INDIAN ROCK LAKE
FRANKLIN COUNTY, MISSOURI
MISSOURI INVENTORY NUMBER 31033

PHASE I INSPECTION REPORT
NATIONAL DAM SAFETY INSPECTION

PREPARED BY: ST. LOUIS DISTRICT CORPS OF ENGINEERS
FOR: GOVERNOR OF MISSOURI
JULY 1978

PHOTO 2 Spillway cut through embankment

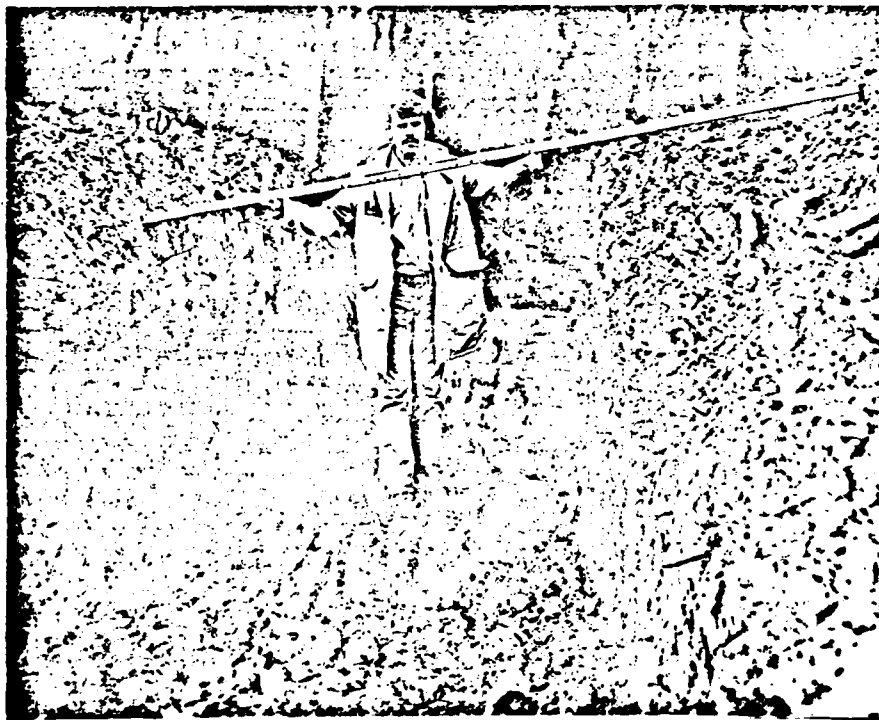
An unprotected 6-foot by 6-foot outlet cut through the embankment as an emergency spillway indicated the dam is unzoned, or of homogeneous construction in the area exposed. Numerous roots were found in the fill material (see photo 2). These roots constitute a potential seepage hazard as they decay. Sidewalls of the cut were firm but the bottom was soft from flowing water. No erosion protection was provided. This earth cut could not be expected to remain intact during any prolonged flow. Significant embankment erosion, and possible failure, would likely occur.

(3) An unprotected 6 feet by 6 feet notch had recently been cut through the embankment near the left abutment to serve as an emergency spillway. The water flowing through the notch was cutting its own exit channel parallel to the toe of the dam to the creek. (See photos 2 and 3).

Approximately 5 cfs was flowing through the notch at the time of the inspection and that flow was eroding the exit channel. Any significant and sustained flows through the emergency spillway could cause excessive erosion of the embankment and the exit channel. The excessive erosions could threaten the safety of the dam.

d. Provide an adequately sized and erosion resistant spillway and exit channel with proper energy dissipators.
